**TO:** All Bidders  
**FROM:** City of Cambridge  
**DATE:** December 10, 2013  
**RE:** File No. 5849C –Dr. Martin Luther King Jr. School Construction  
Project- Addendum NO. 2

**Addendum No. 2**

Regarding: Bid Addendum 2 – Administrative

DR. MARTIN LUTHER KING JR. SCHOOL CONSTRUCTION PROJECT  
CAMBRIDGE, MA  
FILE NO. 5849C

PROJECT NO. 4783.1.00  
 SCALE: AS NOTED  
 DWG. NO.: **SKC - 002**

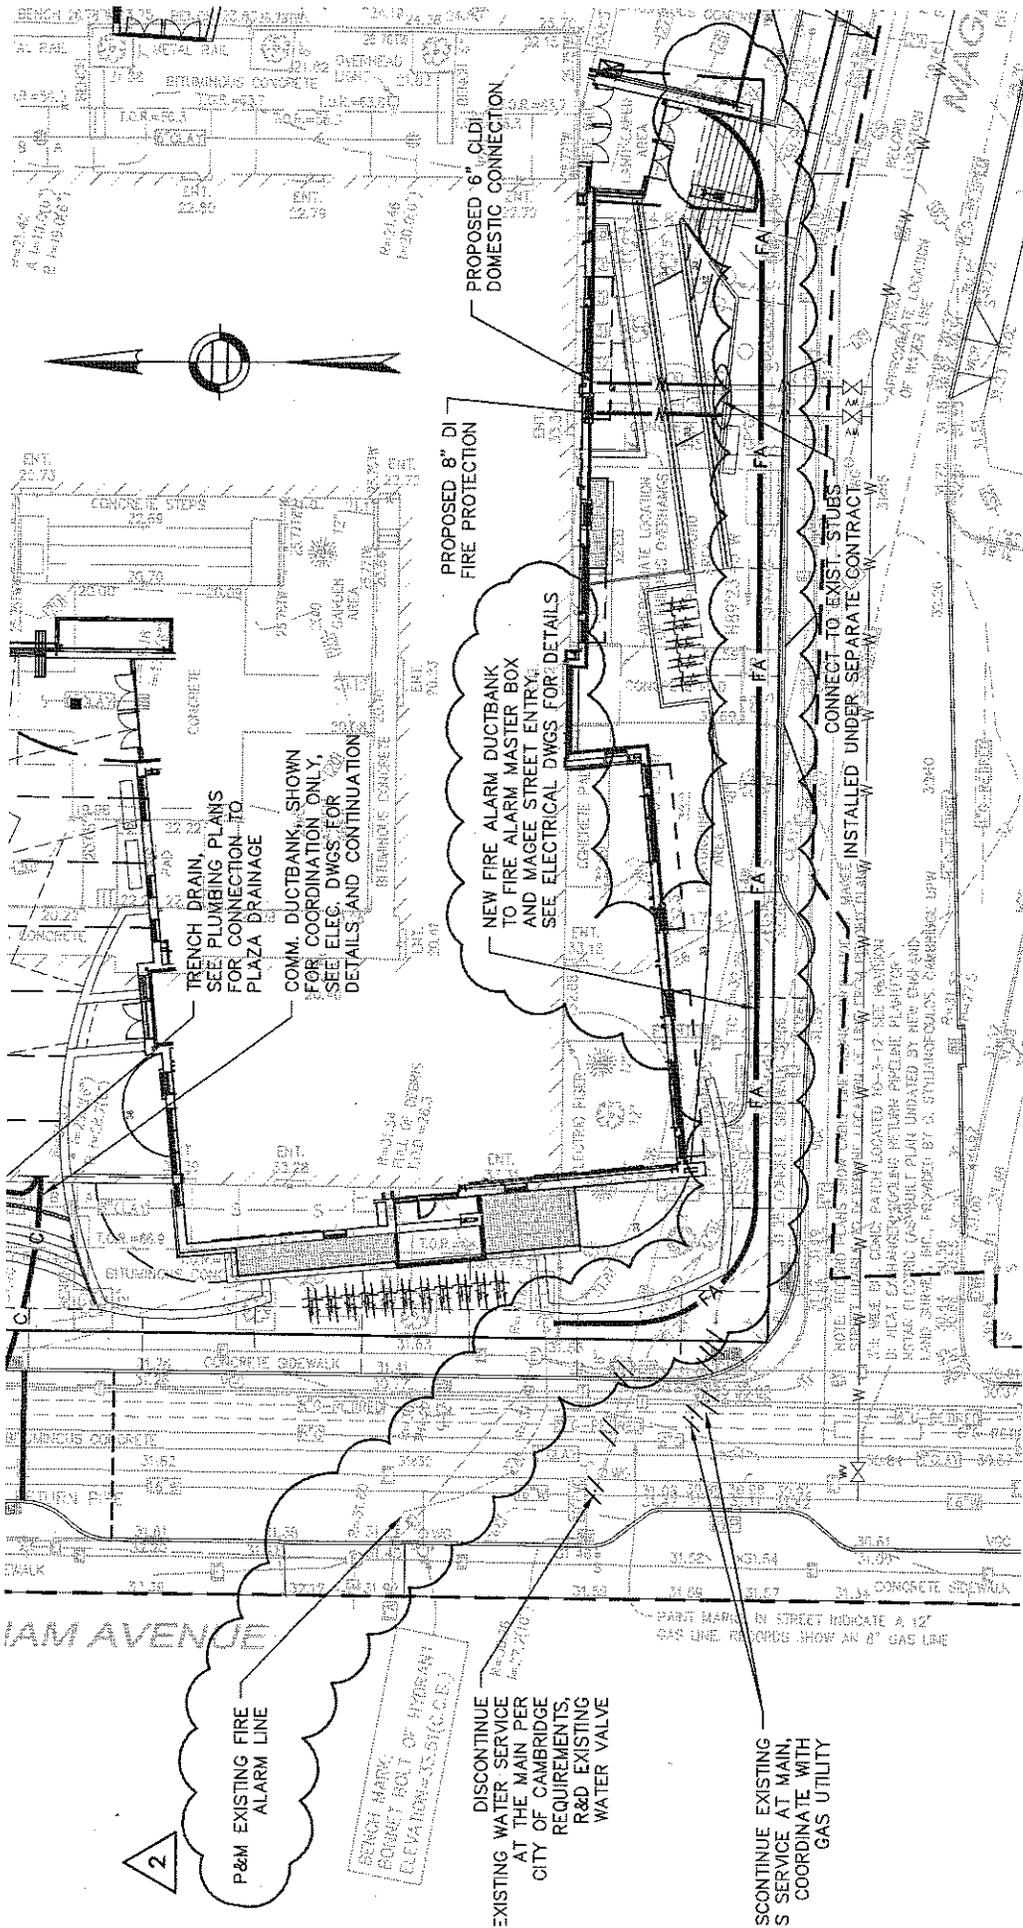
#	DISCIPLINE	ISSUE	DRAWINGS
1	Civil	Subject:	Primary Electrical Service
		References:	SKC-001 and Sheet C100
		Description:	The Bid Set noted the existing electrical service as "protect and maintain". Bid set electrical site plan indicated that the electrical primary service should be removed and replaced. Requirements captured on Plan C100 for coordination. Refer to Electrical Site Plan for details.
2	Civil	Subject:	Gas Service
		References:	SKC-001 and Sheet C100
		Description:	Gas Service connection modified to extend to the main. Contractor shall coordinate actual extents and requirements for installation with gas utility.
3	Civil	Subject:	Sanitary Sewer Labor Division
		References:	SKC-002 and Sheet C100
		Description:	Nitsch Engineering has noted the locations of venting requirements and included oil/gas separator in the civil plan for scope coordination. 4" Kitchen Waste service invert lowered from 17.41' to 17.34' for coordination with plumbing drawings.

PROJECT: Martin Luther King, Jr. School Construction Project  
 DRAWING TITLE: LOCATION OF FIRE ALARM CONDUIT ON MAGEE STREET  
 DATE: BID Addendum 2-12-10-2013

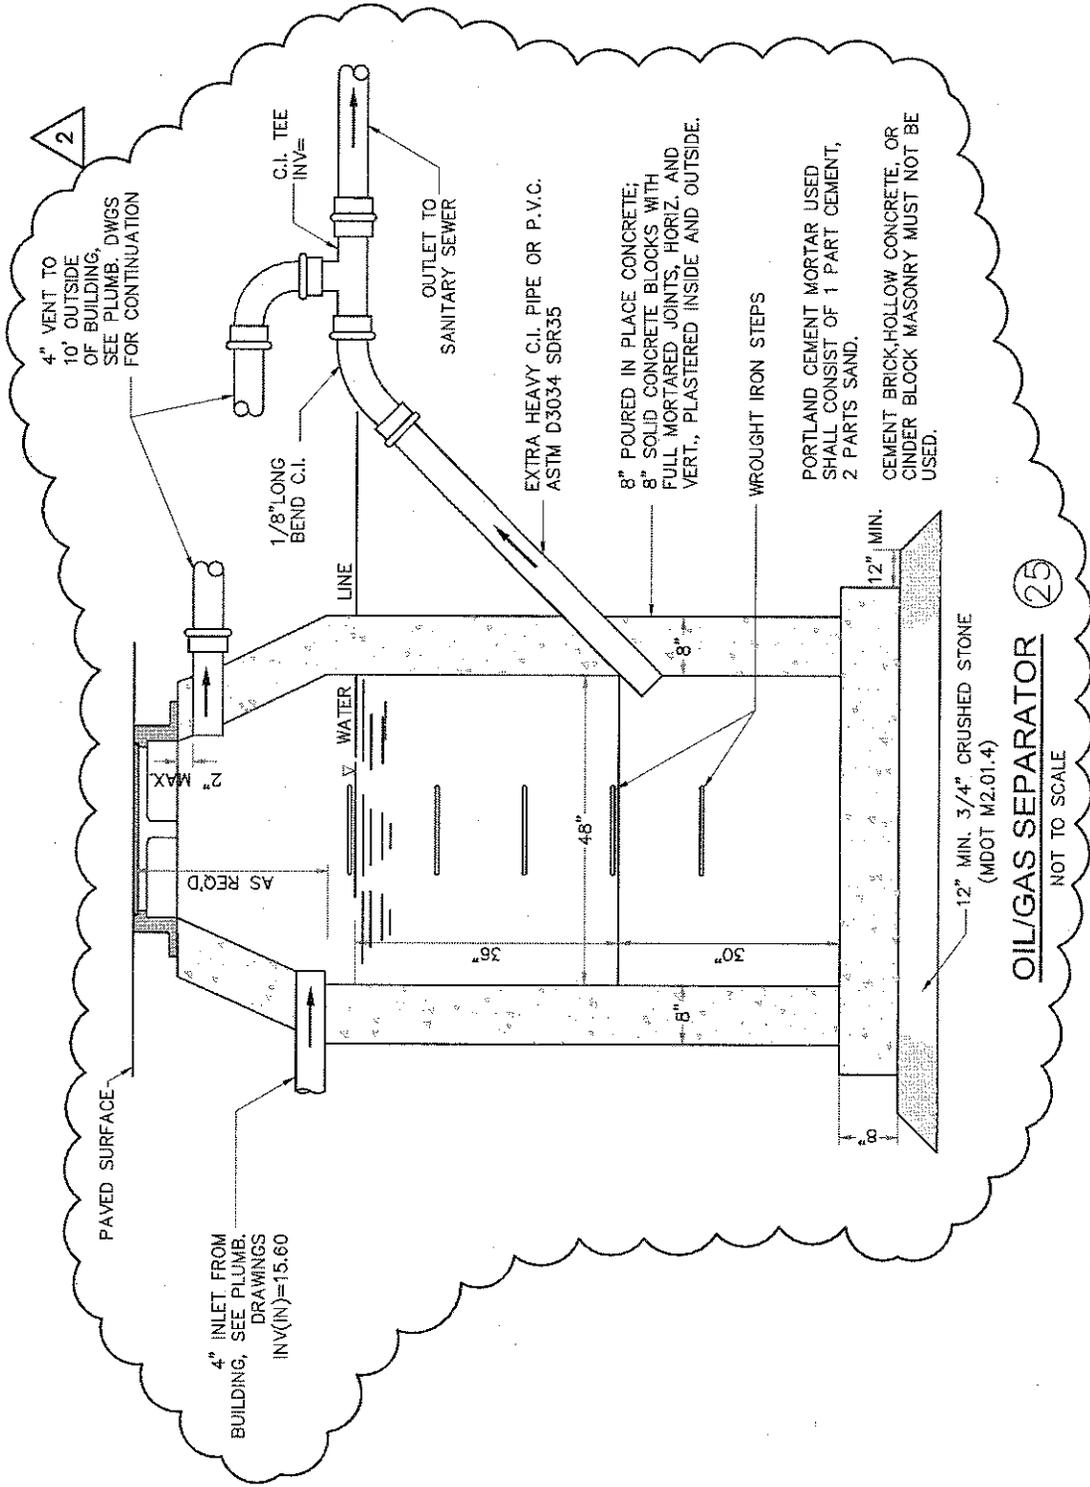
4	Civil	Subject:	Fire Alarm Ductbank
		References:	SKC-003 and Sheet C100
		Description:	Added location of fire alarm ductbank along Magee Street for coordination purposes. Refer to Electrical Site Plan for details.
5	Civil	Subject:	Oil/Gas Separator Detail
		References:	SKC-004 and Sheet C302
		Description:	Oil/Gas Separator detail added to sheet C302.

**PROJECT NO.:** 47931.00  
**SCALE:** 1" = 20'-0"  
**SHEET:**  
**REFERENCE:** L203  
**DWG. NO.:** SKL-001

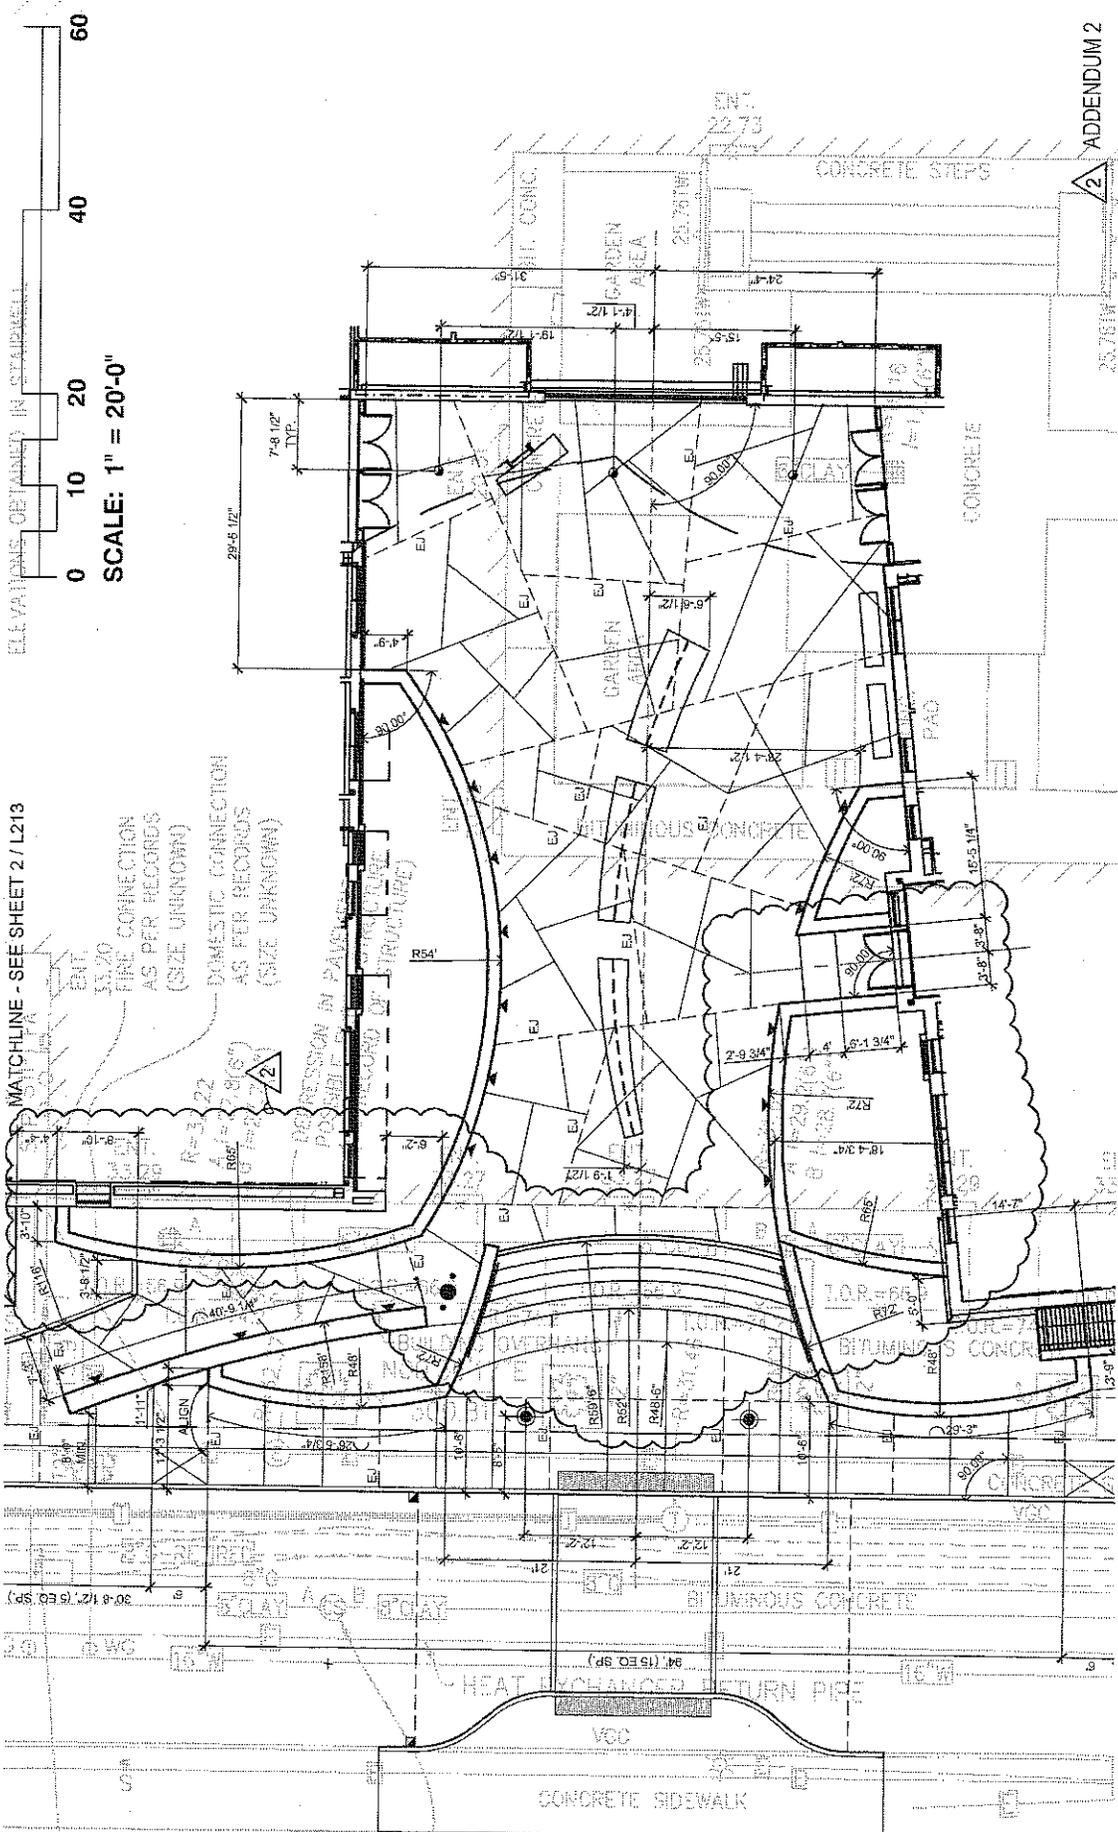
02	Landscape	Subject:	Guardrail gate at Putnam Stair Tower
		References:	2 / L203
		Description:	Add (1) single leaf CLF gate at the top of the stairs leading to the NStar vault. Guardrail to be connected to guardrail end posts. Height to match top of guardrail.
03	Landscape	Subject:	Grading Note changes
		References:	1 / L303
		Description:	Change notes related to Top of Wall elevations to read:  Top of wall elevations are at the FRONT of the coping (LOW point).  And  LOW point of coping to align with calcium-silicate coursing.
04	Landscape	Subject:	Brick Veneer wall details
		References:	1 / L502, 3 / L502, 5 / L502 and 10 / L502
		Description:	Change note "dampproofing" to "WATERPROOFING".
05	Landscape	Subject:	Brick Veneer through wall flashing
		References:	5 / L502
		Description:	Delete "blue skin flashing" and change to "THROUGH WALL FLASHING WITH STAINLESS STEEL DRIP EDGE"
06	Landscape	Subject:	Note Change

DRAWING TITLE: Revision to S100 - Underslab Drainage at US Gym  
 DATE: 12/10/2013 BID ADDENDUM 2

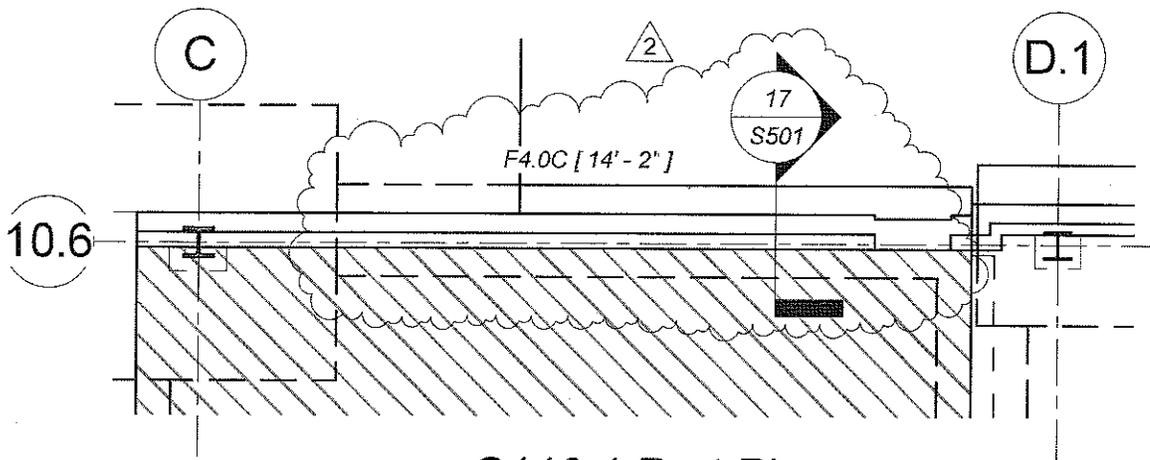
Description:	Revise underslab drainage layout below Upper School Gym. See SKS.
8	Structural	Subject:	Underslab Drainage – Cleanout Elevations
		References:	S100
		Description:	Revise the following cleanout elevations: Cleanout near se3-seA from 20.48' to 20.43' Cleanout near KS5.2-neB from 19.95' to 19.93'
9	Structural	Subject:	Underslab Drainage – Header Pipes
		References:	S100
		Description:	Revise note at header pipes within building footprint (4 locations) from "perforated" to "solid".
10	Structural	Subject:	Existing Perimeter Drainage Lines
		References:	S100
		Description:	Show existing perimeter drainage lines at the following locations: Along the full length of existing wall at EXA, along EX1 between EXA and EXB, and along EX9 between EXA and EXB. Tie the existing perimeter drain into the new underslab drainage system at the south wall of the building (along EX1 between EXA and EXB).
11	Structural	Subject:	Vented Metal Floor Deck

PROJECT NO. 47931.00  
 SCALE: As indicated  
 SHEET REFERENCE:  
 DWG. NO.: **SKS-2**

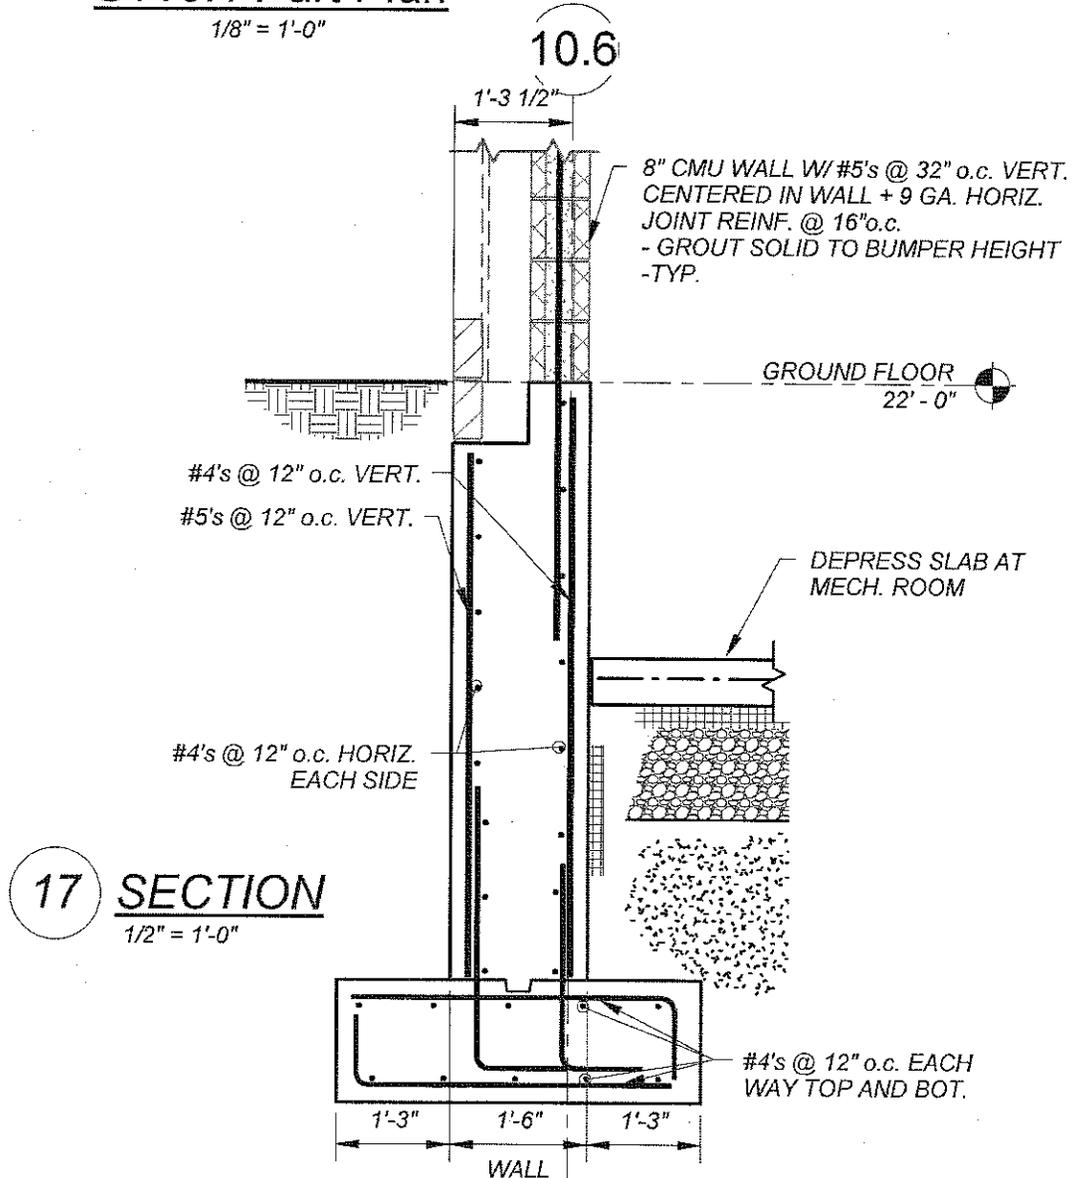
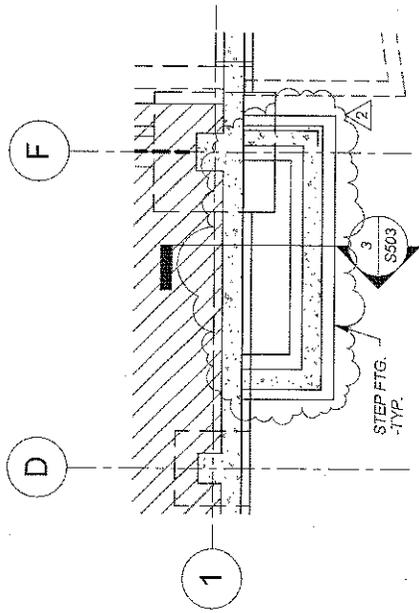
18	Structural	Subject:	Spread Footing Elevation
		References:	S110.1
		Description:	Change footing elevation at Column C.8-EX6 from [11'-3 7/8"] to [11'-6"]
19	Structural	Subject:	Added Section Mark
		References:	S110.1, SKS-2

Description:	Add section reference mark for new Section 17 on S501 to North wall of Mechanical Room 0039. See SKS.
20	Structural	Subject:	Spread Footing Clarification
		References:	S110.1
		Description:	Footing type at Column B.1-12 is F11.0
21	Structural	Subject:	Continuous Footing Clarification
		References:	S110.1
		Description:	Move F2.0C tag for North wall of NSTAR Vault to the East to coincide with Section 4 on S502 section mark.
22	Structural	Subject:	Continuous Footing Clarification
		References:	S110.1
		Description:	Revise footing elevation tag for 12" infill wall along EX9 at existing stair to actual elevation of +/-18'-8" instead of relative elevation for clarity.
23	Structural	Subject:	Continuous Footing Clarification
		References:	S110.1
		Description:	Change F2.0C tag to F2.5C for East wall of NSTAR Vault and add F2.5C tag to South wall for clarity.
24	Structural	Subject:	Continuous Footing Clarification

**PROJECT NO.:** 47831.00  
**SCALE:** As indicated  
**SHEET REFERENCE:**  
**DWG. NO.:** **SKS-3**

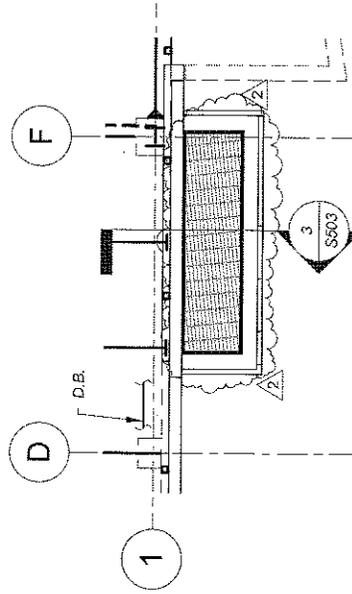
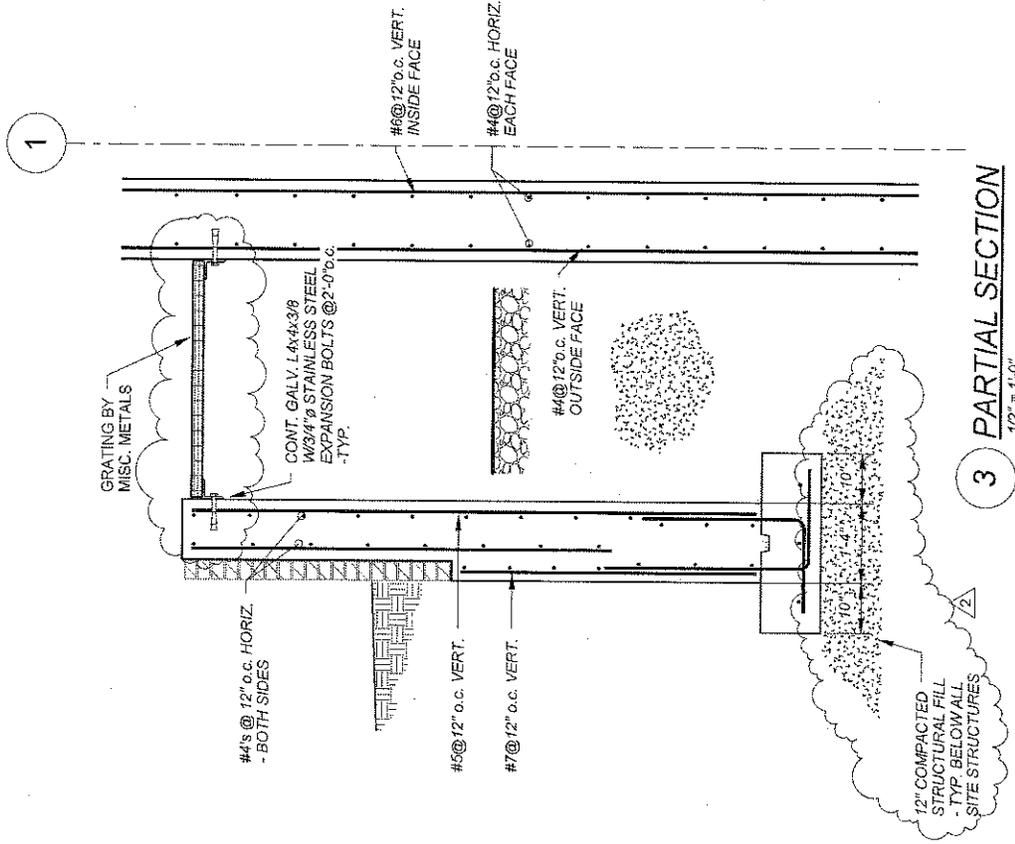
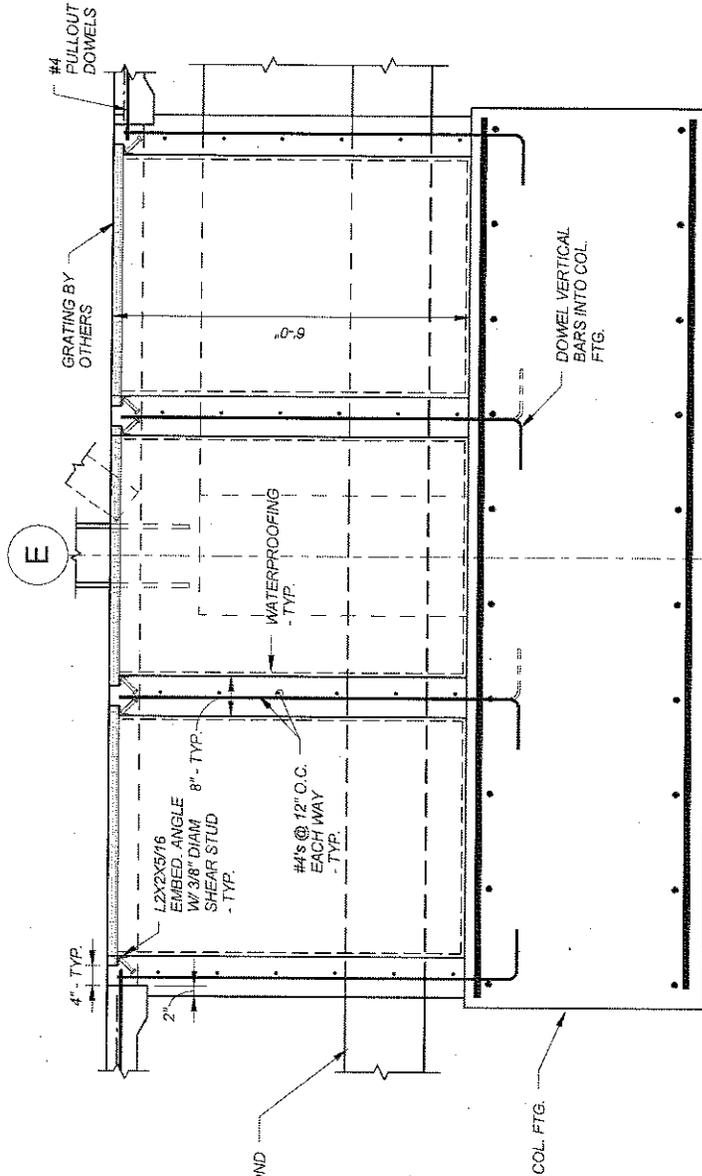
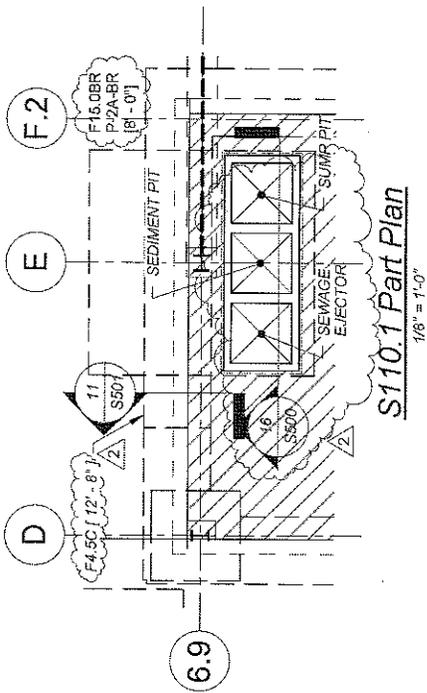
between lines B and C, locate one 4'-0" North of line EX4, locate the other 4'-0" North of line EX2.
41	Structural	Subject:	Magee Street Areaway Revisions
		References:	S110.4, S111.4, Section 3/S503, SKS-3
		Description:	Revised areaway walls and footings and add grating as shown in SKS.
42	Structural	Subject:	Spread Footing Deletion
		References:	S110.4
		Description:	Delete F4.0 footing on 1 between D and F.
43	Structural	Subject:	Continuous Footing Clarification
		References:	S110.4
		Description:	Revise elevation for 30" thick mat below storage tanks to actual elevation of 9'-4" instead of relative elevation of [-12'-8"] for clarity.
44	Structural	Subject:	Continuous Footing Clarification
		References:	S110.4
		Description:	Add F2.5C tags wall along sw1 to match Section 9/S500.
45	Structural	Subject:	Continuous Footing Clarification
		References:	S110.4
		Description:	Change F2.0C tags to F4.5C for walls at Mechanical Room 0056 to match Section 9, 10 and 11/S501. Bottom of footing elevation [13'-2"] Change F2.0C tags to F4.0C for walls at Mechanical Room 0058, bottom of footing elevation [14'-2"]
